CPSES-200501308
Log # TXX-05115
File # 00236

**SUBJECT: COMANCHE PEAK STEAM ELECTRIC STATION (CPSES)
DOCKET NOS. 50-445 AND 50-446
LICENSE AMENDMENT REQUEST (LAR) 05-003
REVISION TO TECHNICAL SPECIFICATION (TS) 5.5.13, "DIESEL
FUEL OIL TESTING PROGRAM"**

ATTACHMENT 1 to TXX-05115
DESCRIPTION AND ASSESSMENT

PROPOSED TECHNICAL SPECIFICATION CHANGES (MARK-UP)

INSERT E

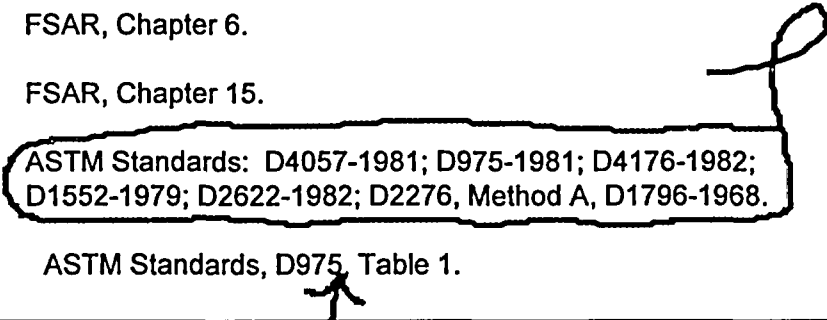
Lastly, the proposed changes add three ASTM Standards, D1298-1980, D4294-2003, and D5452-2000, to reference 6 and the revision year to the ASTM Standard D975 to reference 7 in the Reference section for TS Bases 3.8.3. The proposed changes are consistent with the wording in section 5.5.13 of NUREG-1431, Revision 3, "Standard Technical Specifications, Westinghouse Plants" (STS), since STS has already incorporated TSTF-374-A. These proposed changes are administrative in nature. The required quality and quantity of DG fuel oil will not change.

INSERT E

ASTM Standards: D4057-1981; D975-1981; D1298-1980; D4176-1982; D1796-1968; D1552-1979; D2622-1982; D4294-2003; D2276-1978, Method A; D5452-2000.
